ADDENDUM No. 1
Reconstruct GA Apron – Phase 1 Construction
March 12, 2024

Reconstruct GA Apron – Phase 1 Construction

FAA AIP No. 3-19-0028-078
Iowa DOT No. 91240DBQ100

03 **TYPE "A-2" - 1 INCH ISOLATION JOINT**
SCALE: NONE

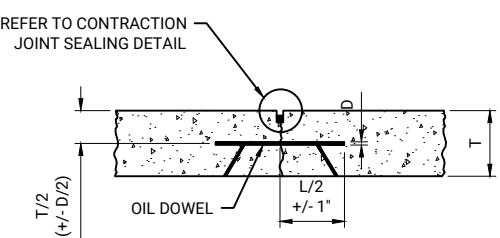
- **Plan Sheet B.02 – Typical Cross Sections and Details**
 - **REVISE** Detail 03 to “Type “A-2” – 1 Inch Isolation Joint”.
 - **ADD** Joint width dimension of 1/2” +/- 1/16” to Detail 07 *Construction Joint Sealing Detail* and Detail 08 *Contraction Joint Sealing Detail*.

SHEET NO.
J.03

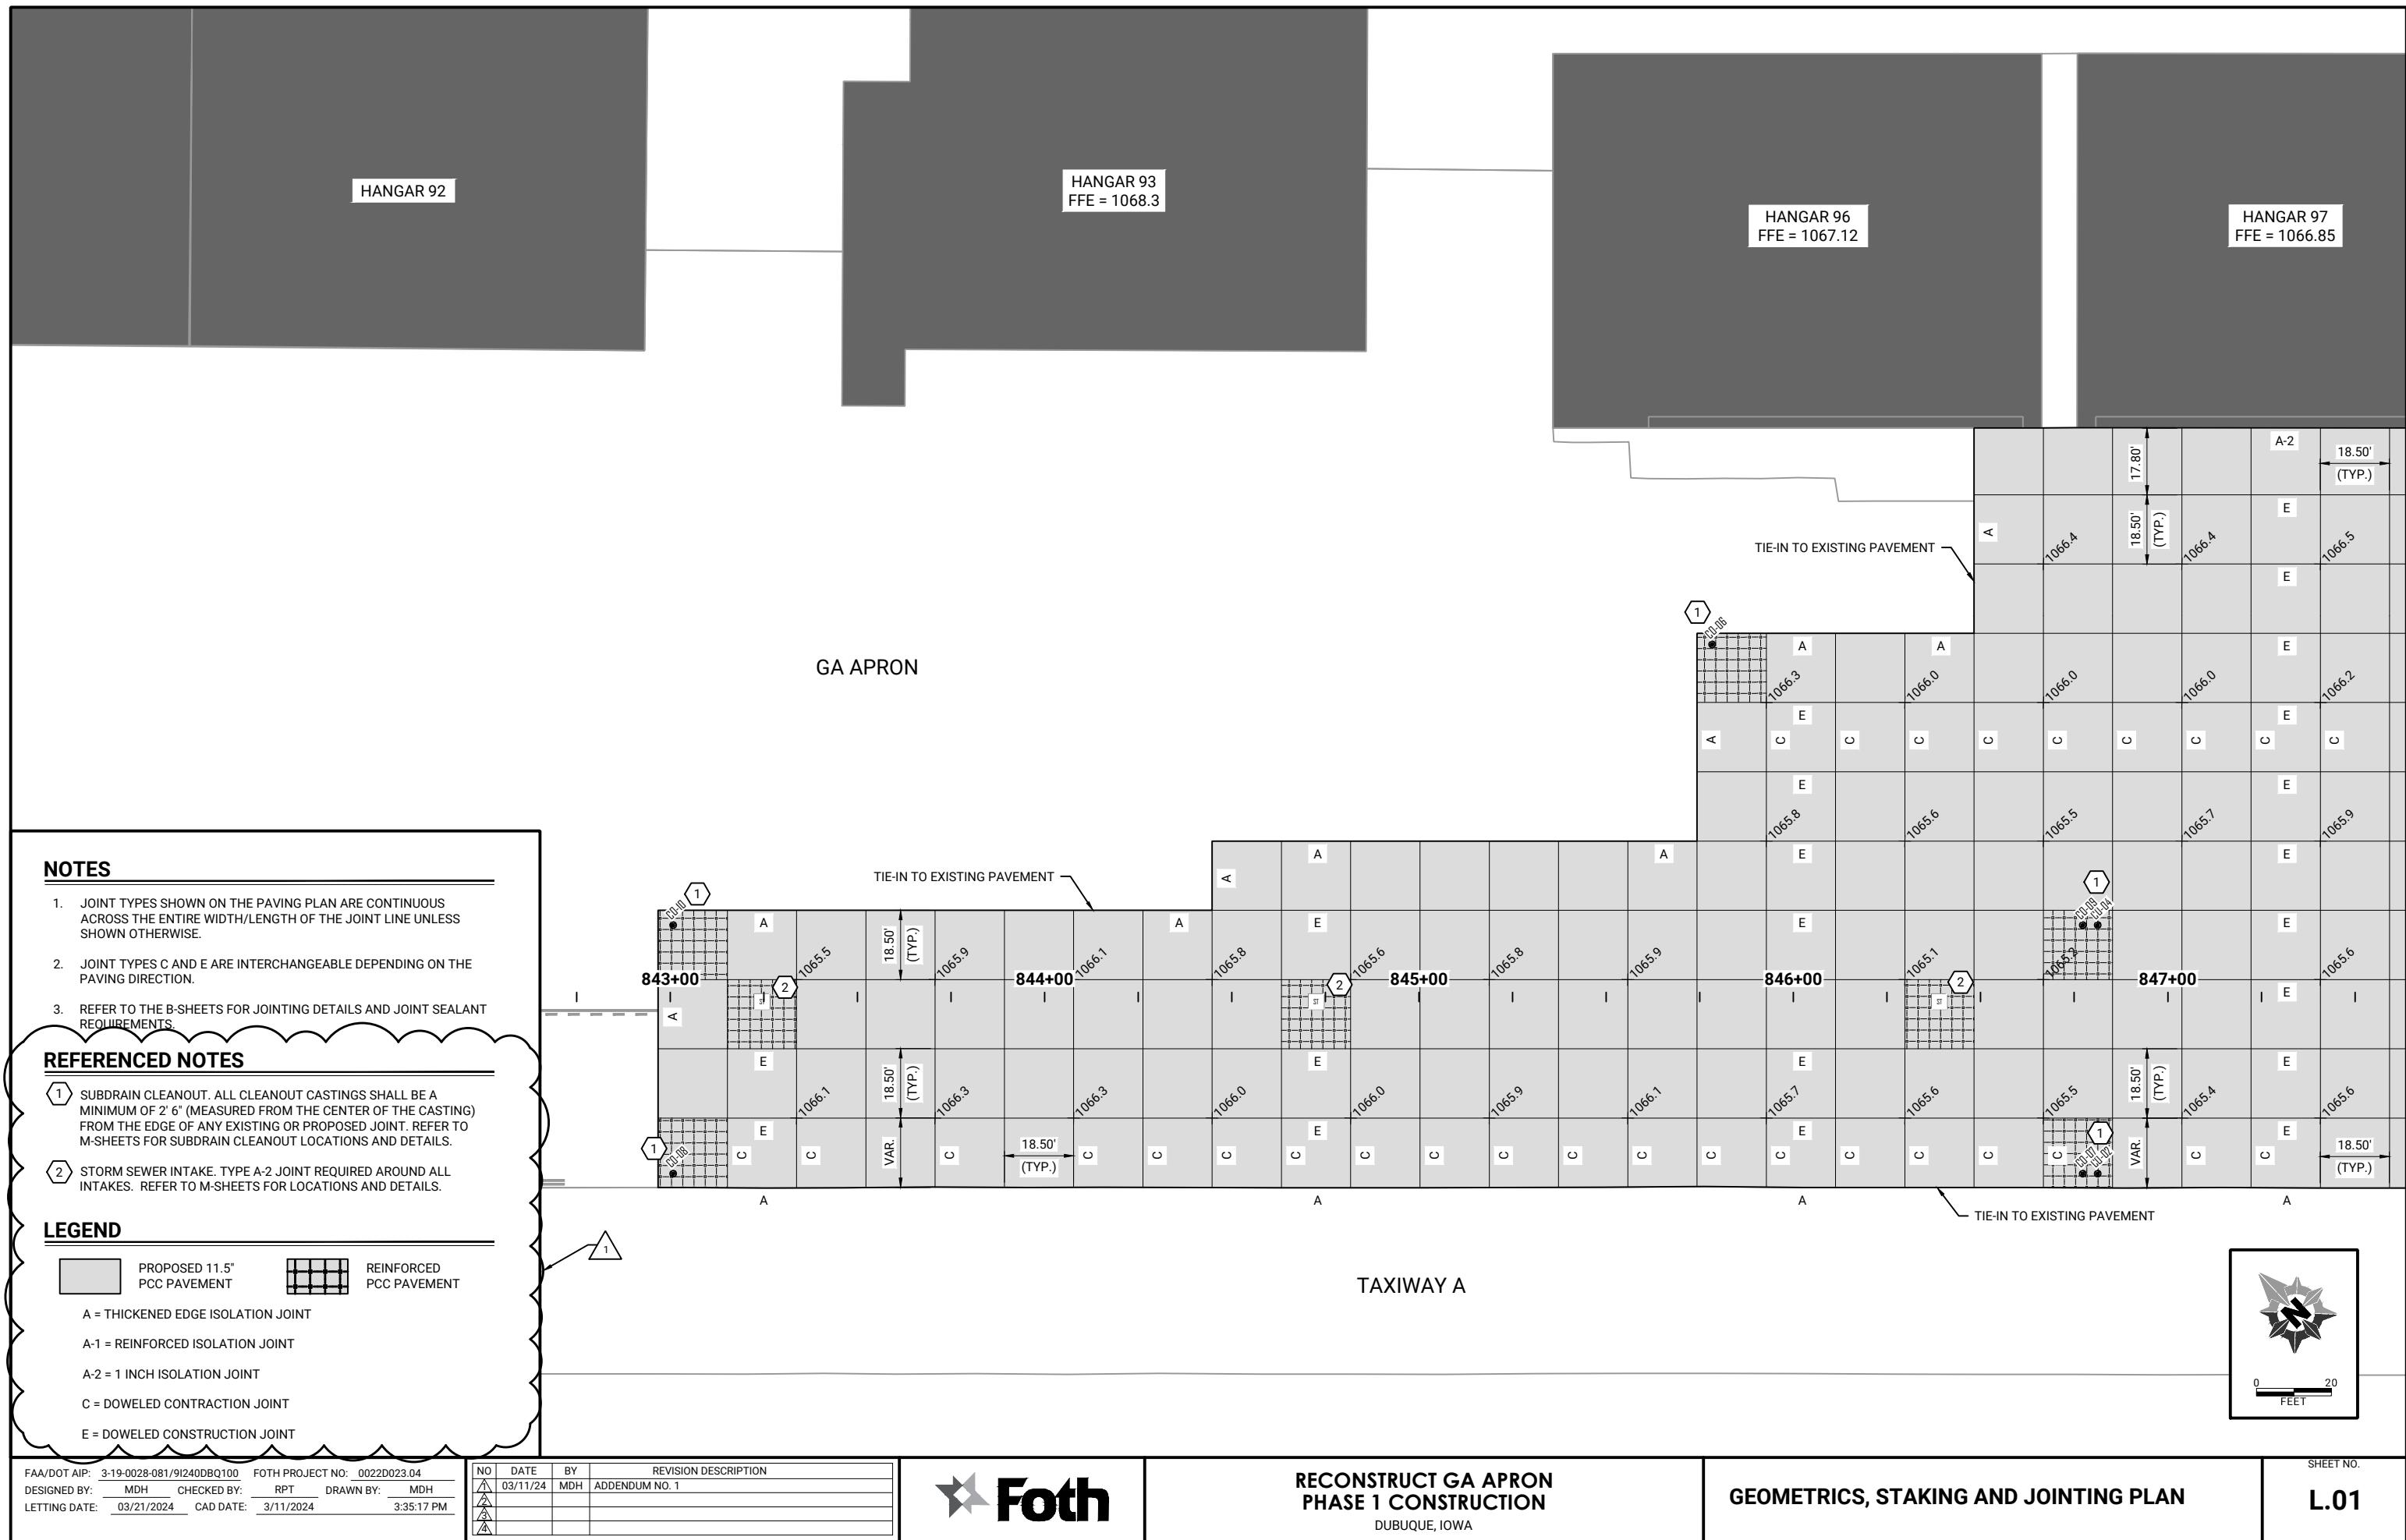
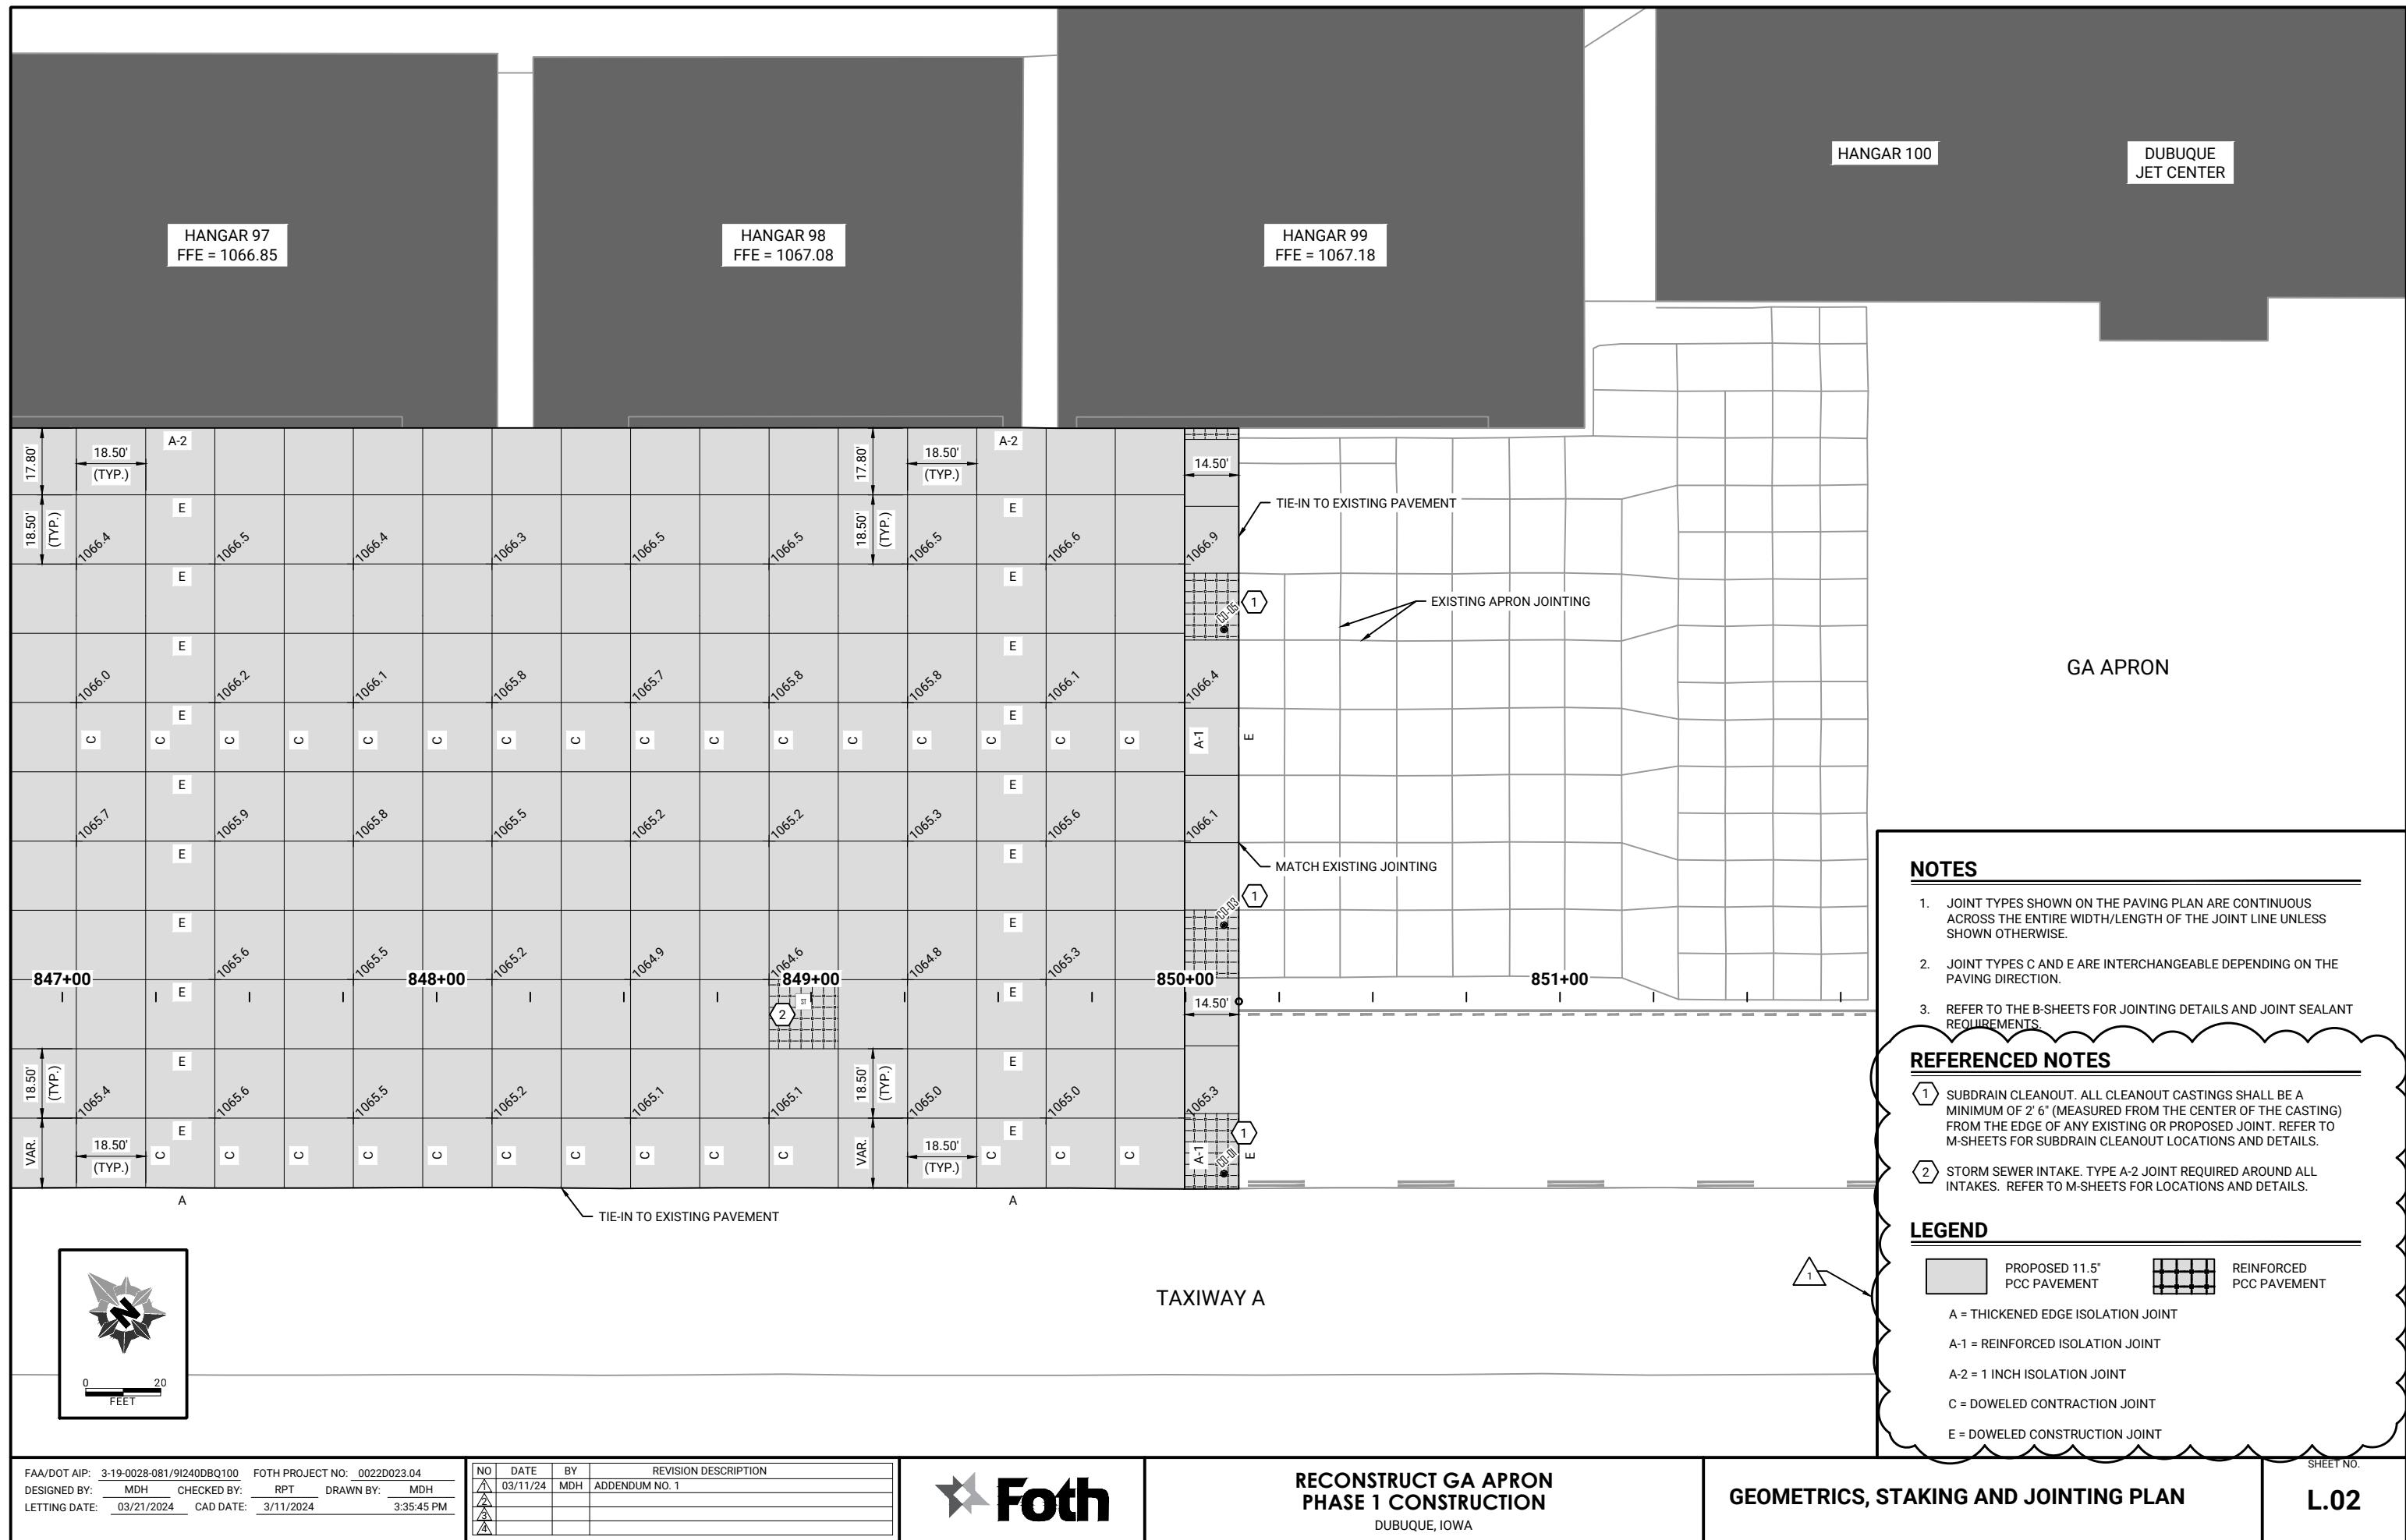
- **Plan Sheet J.03 – Construction Safety and Phasing Plan – Overall Safety and Phasing Plan**
 - **ADD** Note “Contaminated Soils Stockpile Location. Refer to Sheets C.02 and U.03 for Details.”

SHEET NO.
L.02

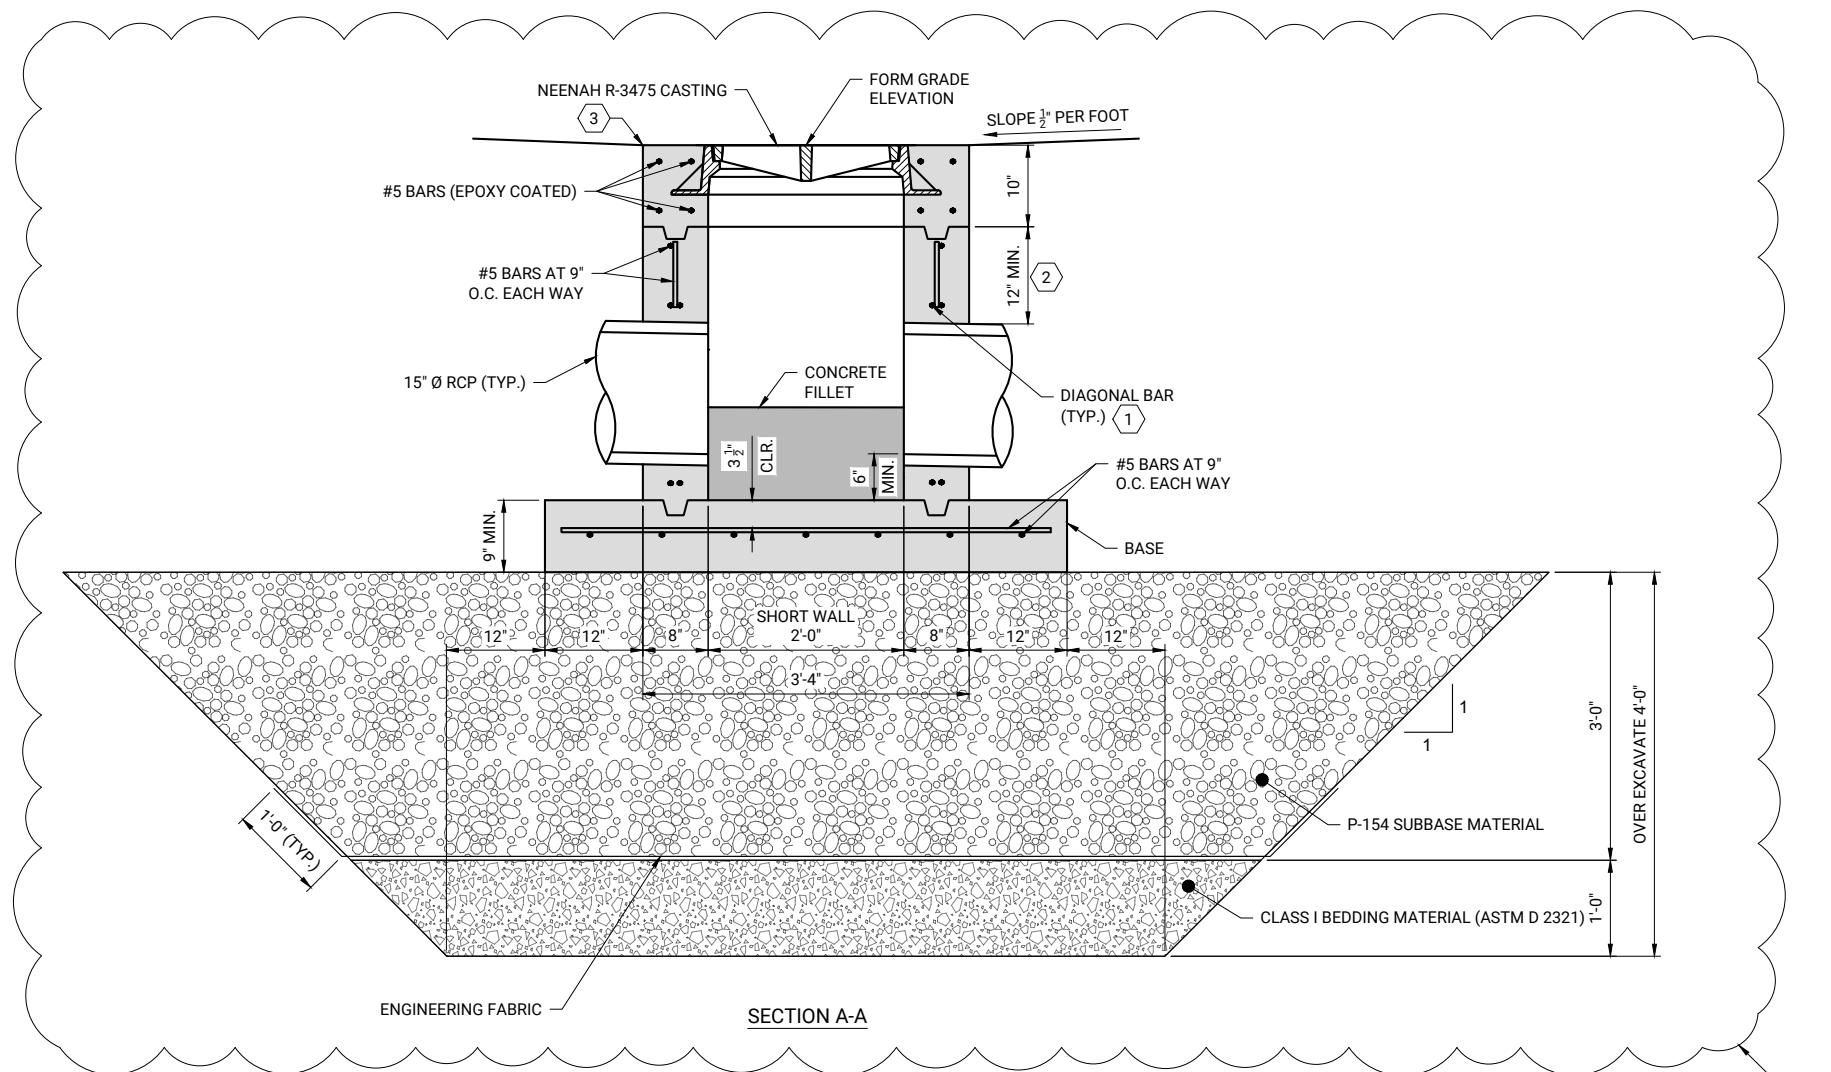
- **Plan Sheet L.01 and L.02 – Geometrics, Staking, and Jointing Plan**
 - **REVISE** Referenced Note 2 to “Storm Sewer Intake. Type A-2 Joint Required Around All Intakes. Refer to M-Sheets for Locations and Details.”

- **REVISE** “A-2 = 1 Inch Isolation Joint at Hangar” to “A-2 = 1 Inch Isolation Joint”.
- **Plan Sheet M.06 – Storm Sewer and Subdrain – Storm Intake Details**

01 MODIFIED SW-511 SINGLE GRATE INTAKE

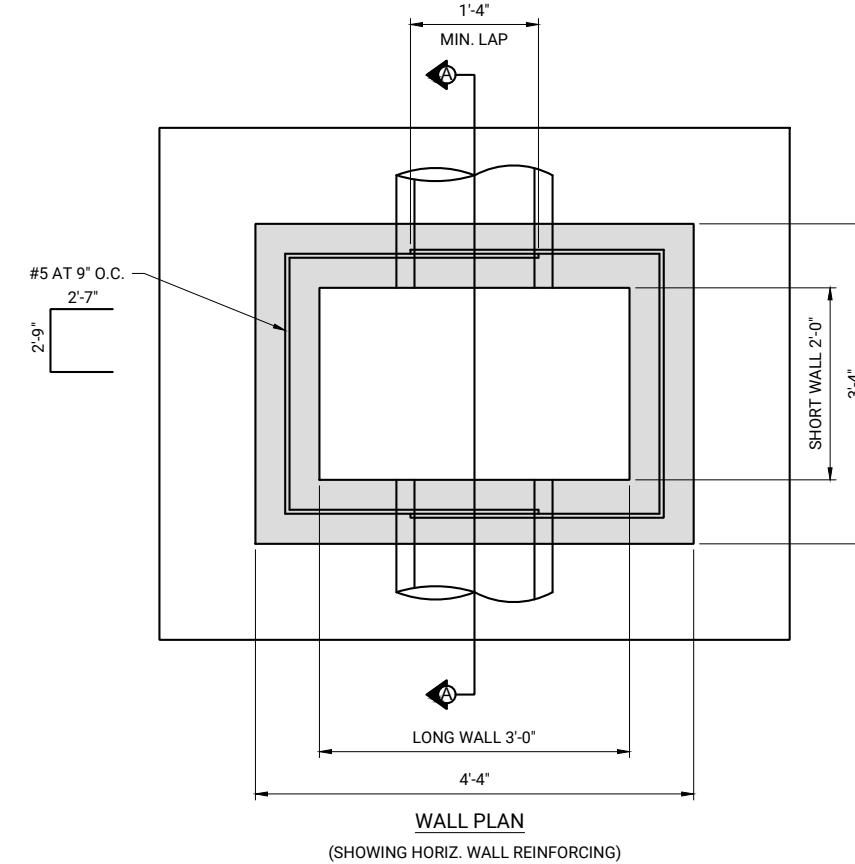
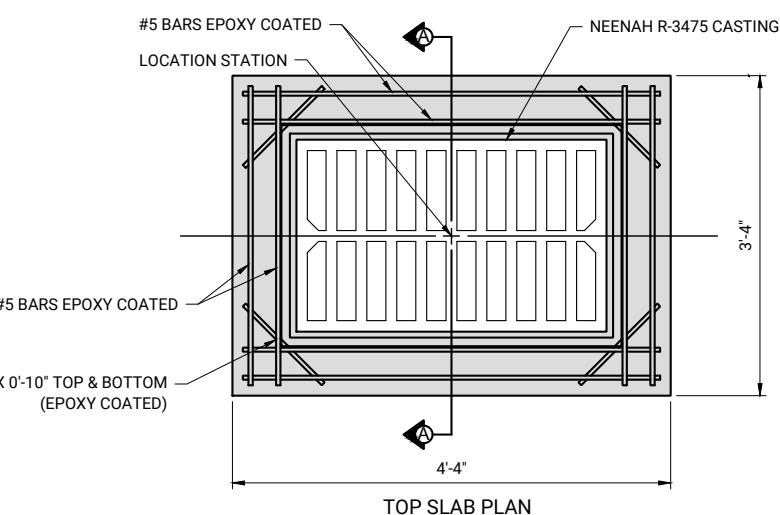
- **ADD** Referenced Note 3 “Type “A-2” – 1 Inch Isolation Joint. Refer to B-Sheets and L-Sheets for Details.”
- **Plan Sheet U.03 – Storm Water Pollution Prevention Plan (SWPPP) – Contractor Staging/Batch**
